CONSERVATION COMMISSION AGENDA

Date: January 11, 2018

- 4. NOI (continued) – 56 Farwell Street – DEP File #239-793**
- Request: Construct six single-family homes & driveways. Construct private road. Increase flood storage capacity. Implement restoration planting plan along river.

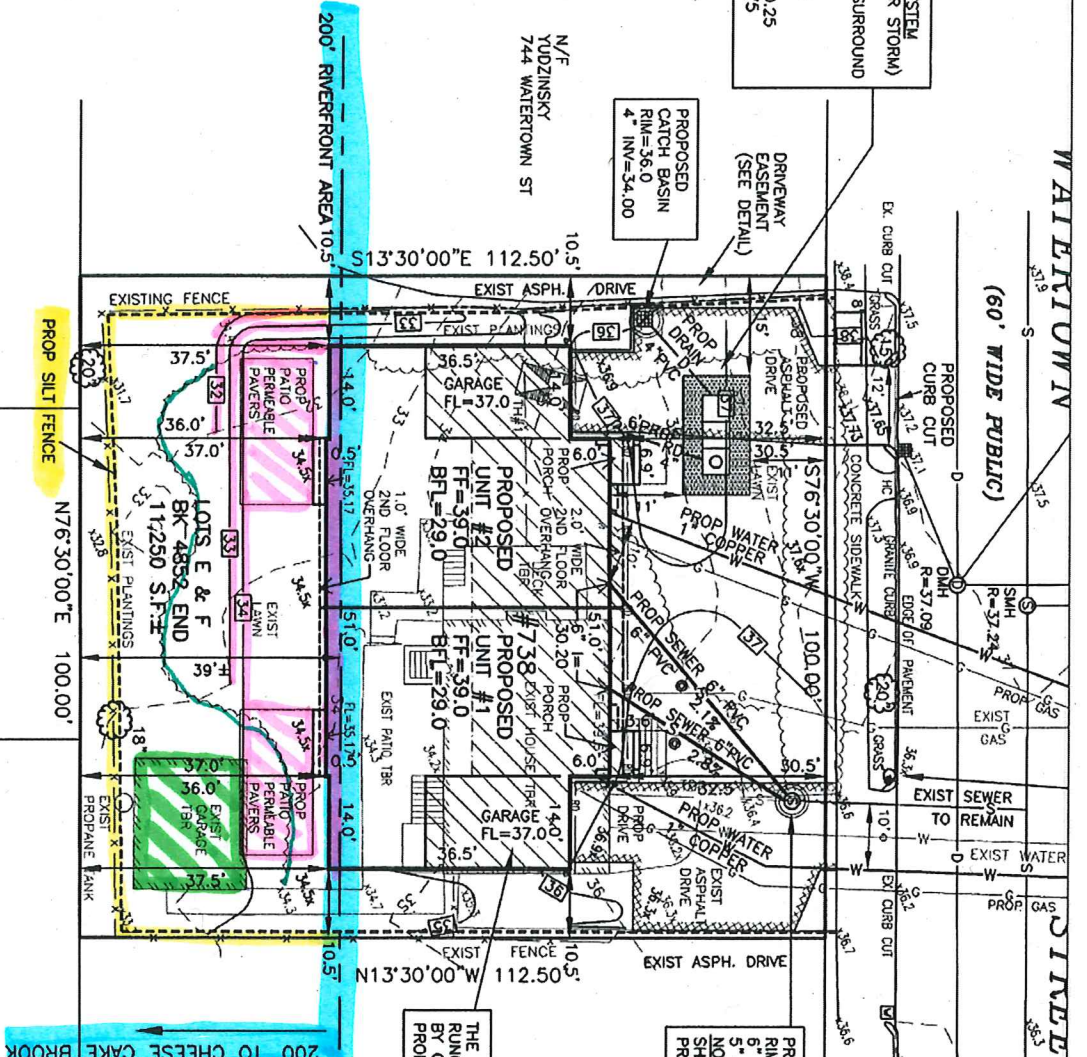
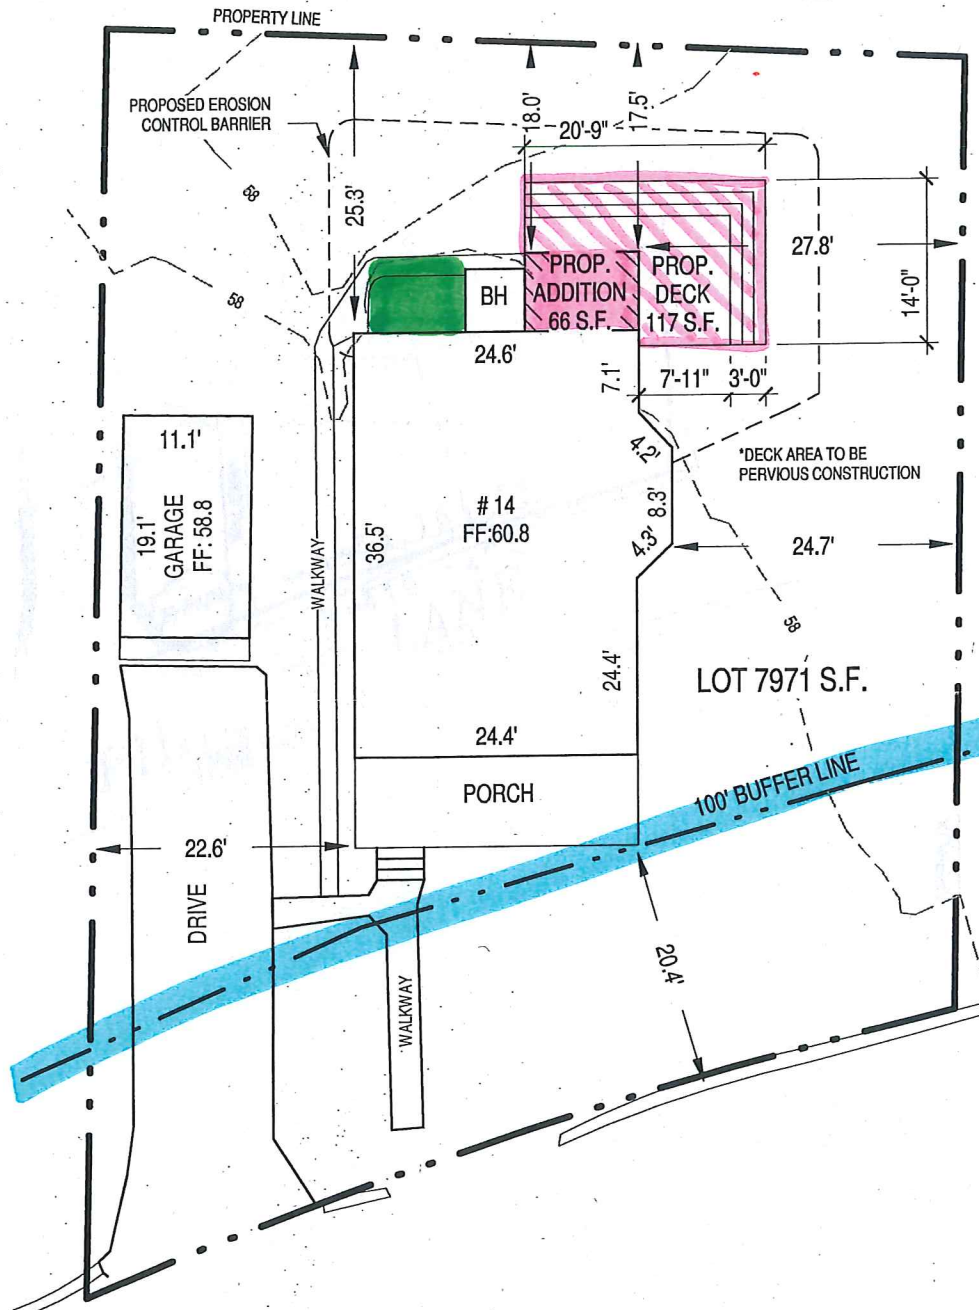
- Staff notes:
 - No site visit has been made as of the drafting of this agenda.
 - The only construction activities within RFA are:
 - removal of the 270 sf garage (exempt)

- installation of 400 sf of pervious patios (exempt)
 - re-grading of existing lawn on one side (185' from Cheesecake Brook)
 - construction of 1.5-2 feet (133 sf) of the house (198' from Cheesecake Brook)

- There will be a net 137 sf reduction in impervious area within RFA
 - All roof runoff will be infiltrated in the front yard outside of the RFA.
- Staff recommendation: If the Commission feels that the construction activities are so marginally within the RFA as to not alter its function or value, vote to issue a negative 2 DOA (work is within a jurisdictional area, but will not remove, fill, dredge, or alter). Include the following conditions:

- The trees (roots, trunk, and branches) along the rear fence line may not be disturbed.
 - Erosion controls (entrenched silt fence) must be installed to protect the existing vegetation along the rear fence line.

**DEFINITIVE PLAN OF LAND
PROPOSED PRIVATE WAY OFF
FARWELL STREET
"GRADING AND DRAINAGE PLAN"
NEWTON, MASSACHUSETTS**

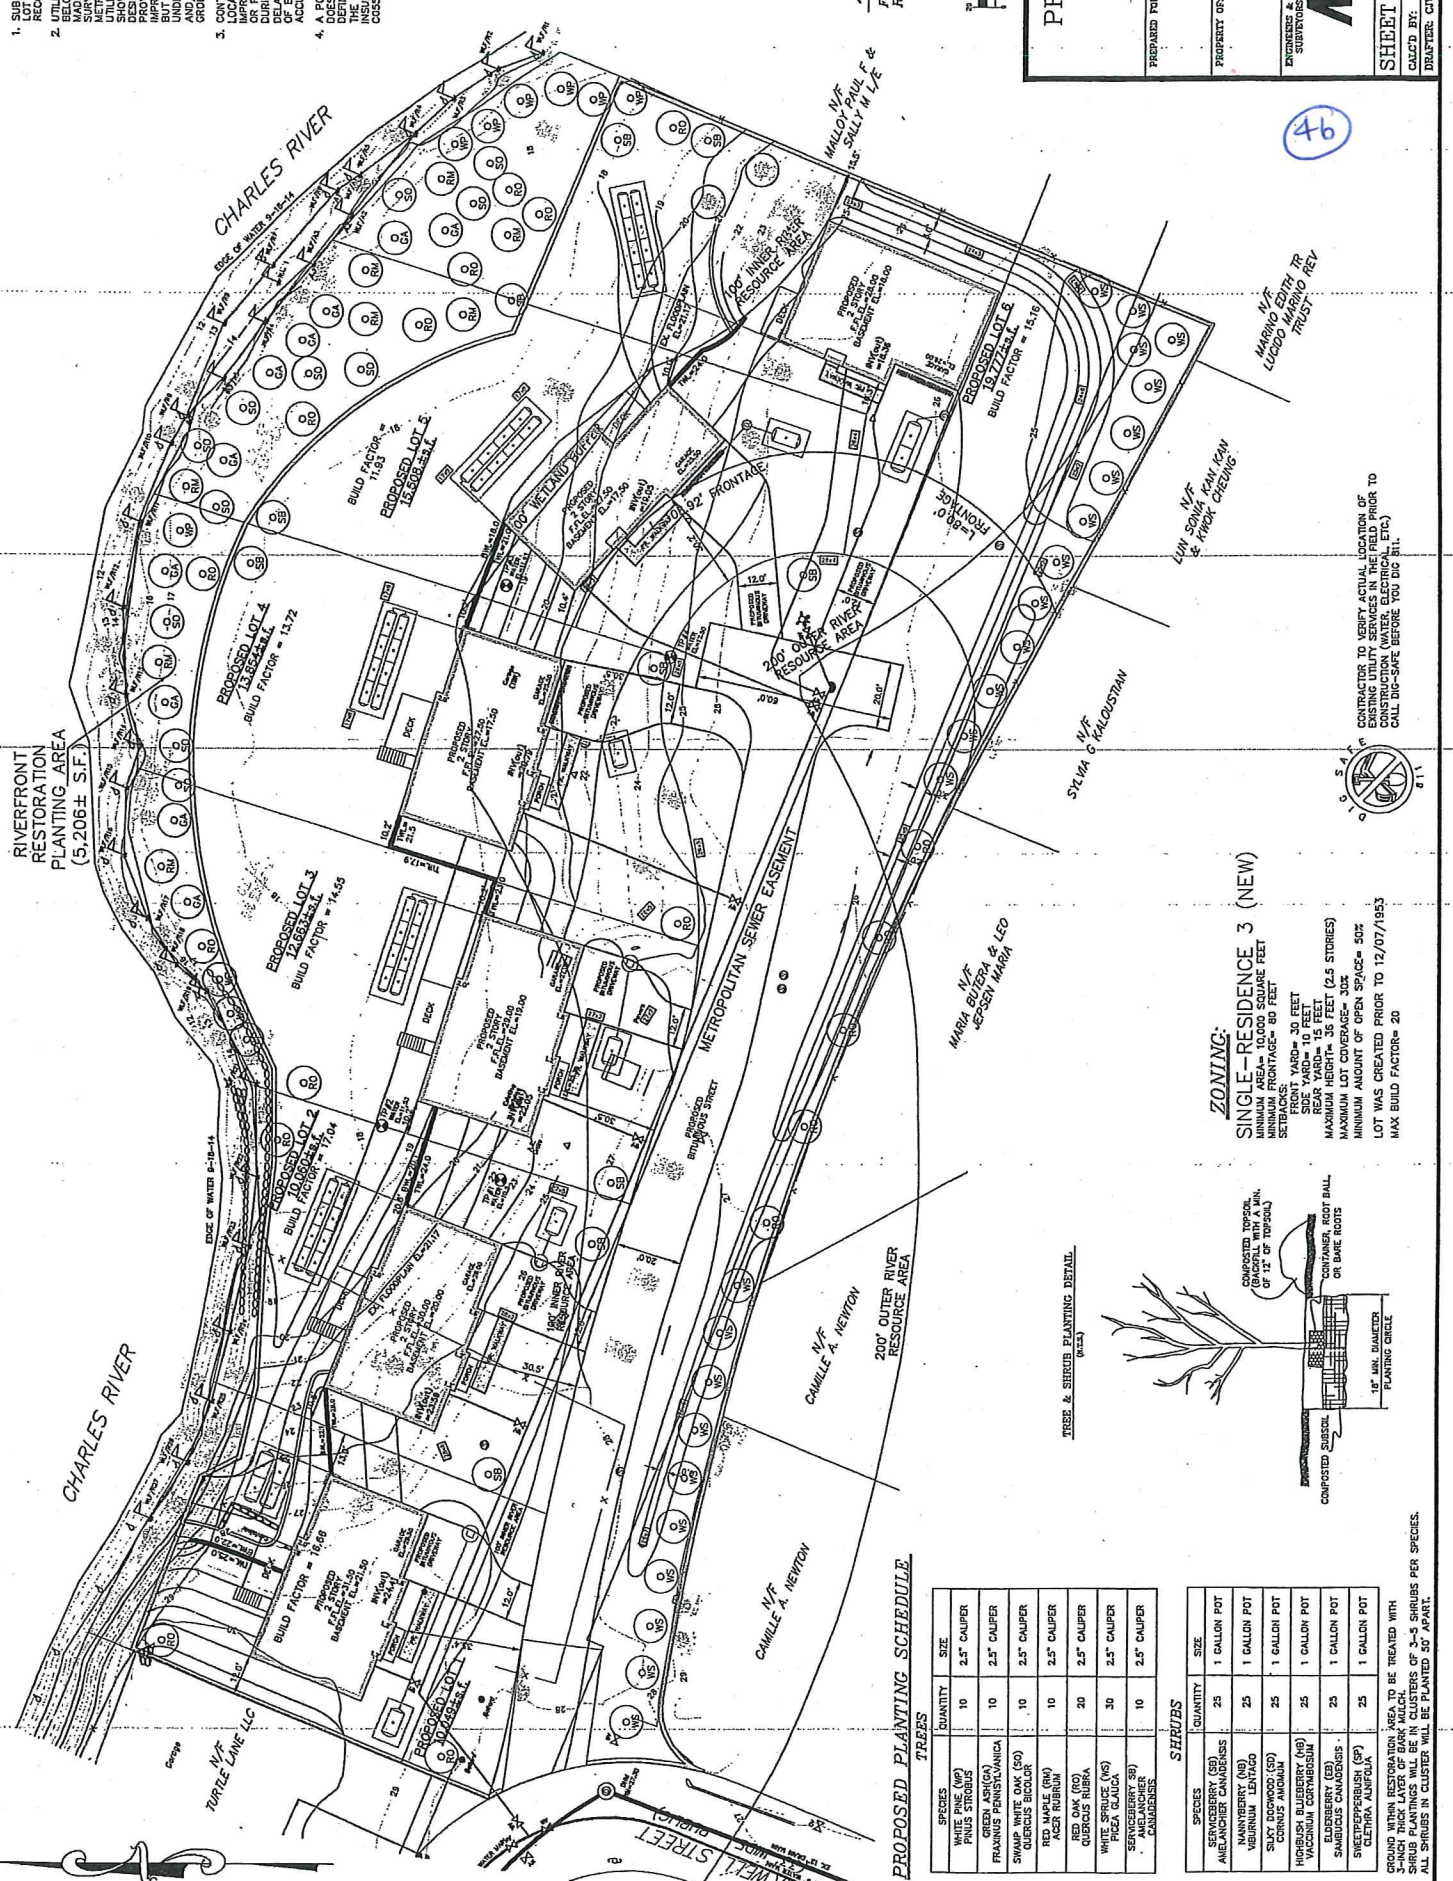
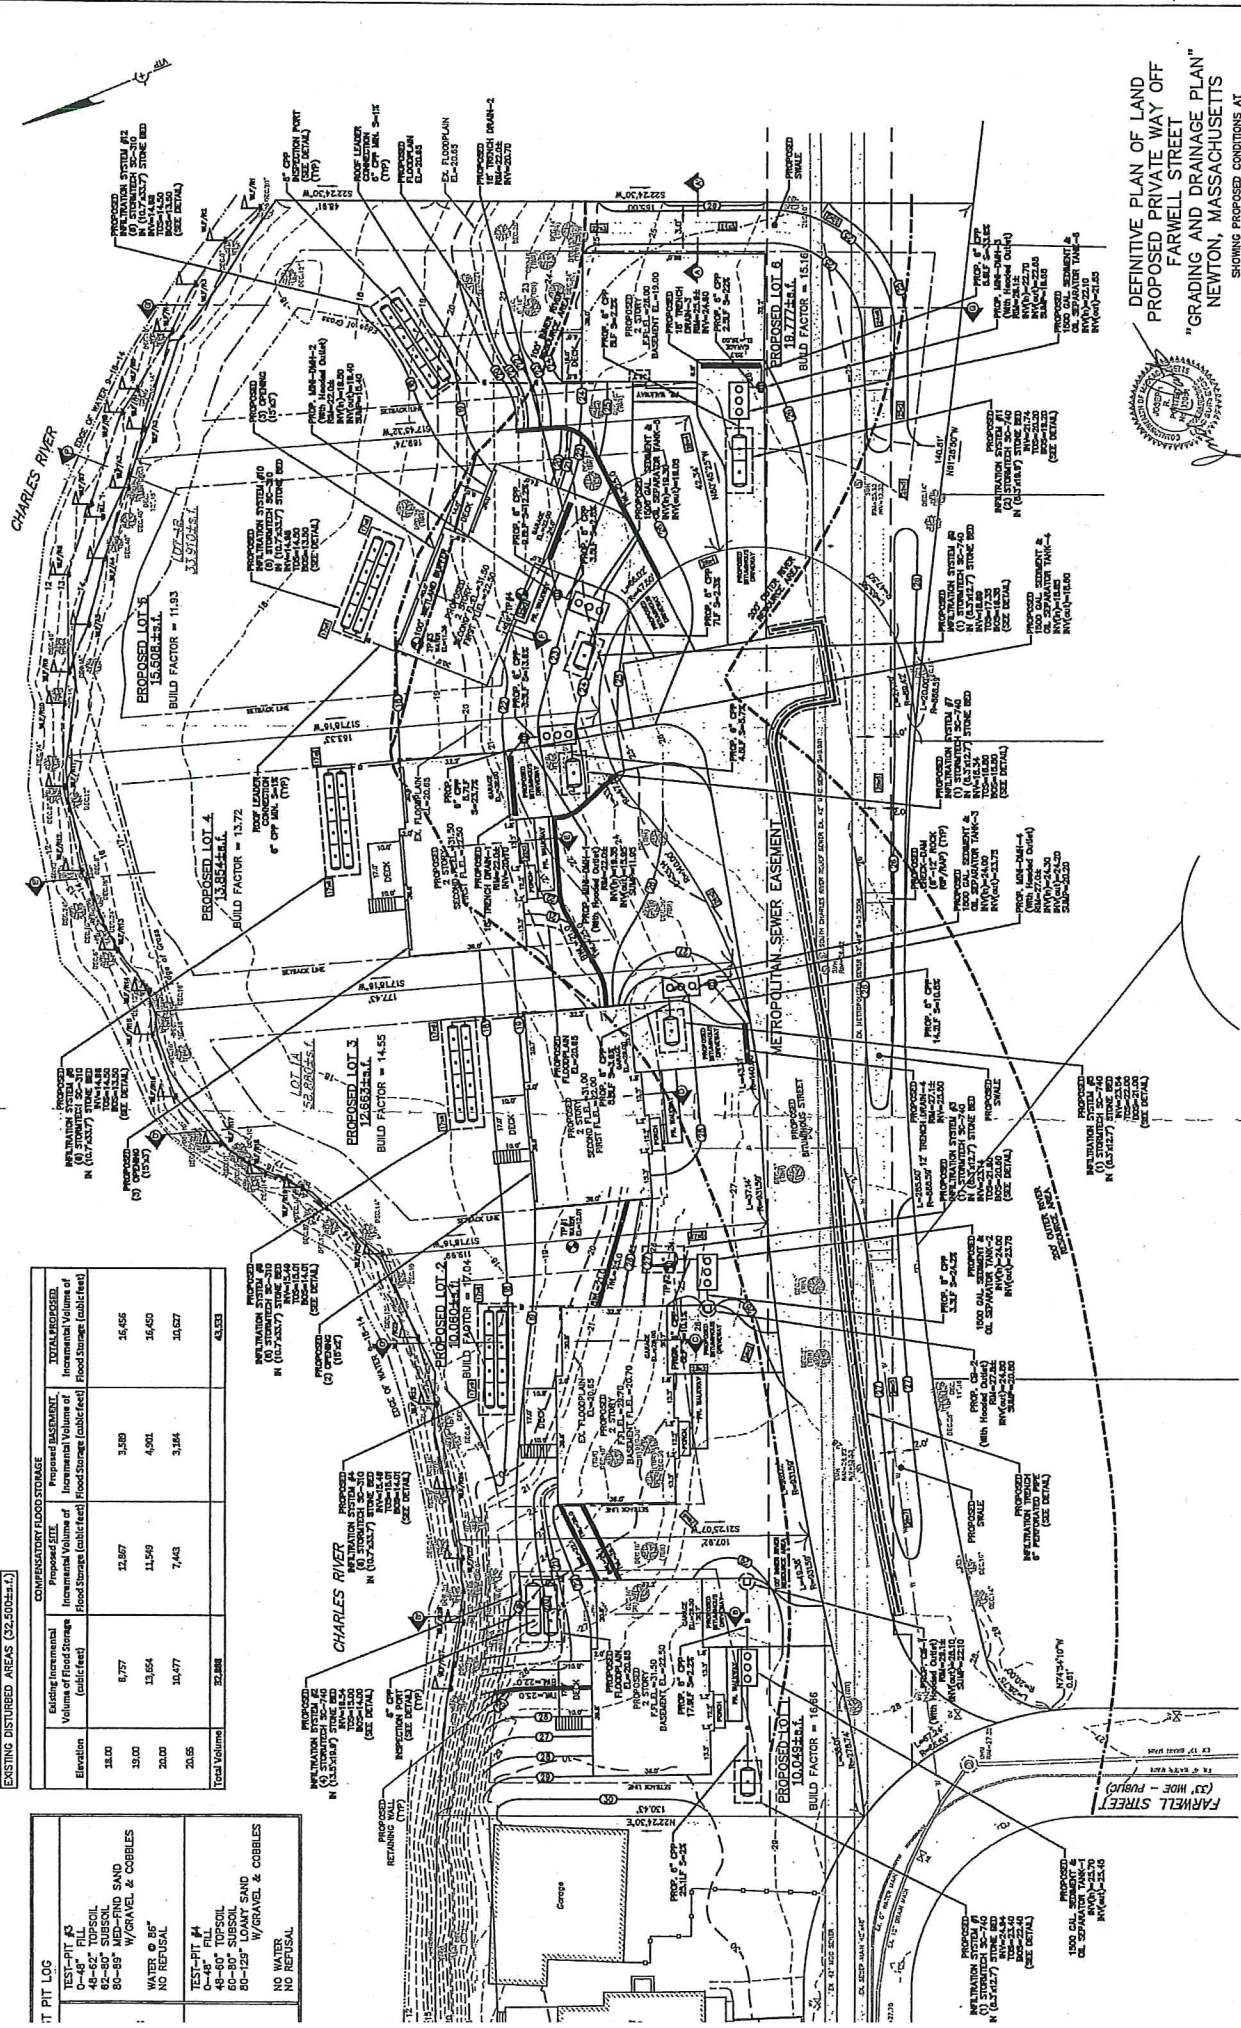
- Test pits must be done within 25’ of each infiltration system (per engineering).
 - Proposal will cause removal of huge oaks. There should be a chart of trees to be removed (size and species) – and a comparison of trees and shrubs to be planted.

- I didn't see any reference to the seed mix on the plans (area, application rate, etc.)
- O&M? Who will be responsible for street sweeping, snow removal, and inspection/maintenance of the infiltration systems?

- The vegetated buffer is extremely narrow near lots 1 and 2.
- The vegetated buffer could easily be widened near lots 3, 4 and 5.
- The continuous retaining wall bars access from front yards to back yards – completely impractical.

- The grading doesn't create usable yards. The lack of lawn will cause owners to tend to encroach on buffer and/or fill (in flood zone) to expand their yards.
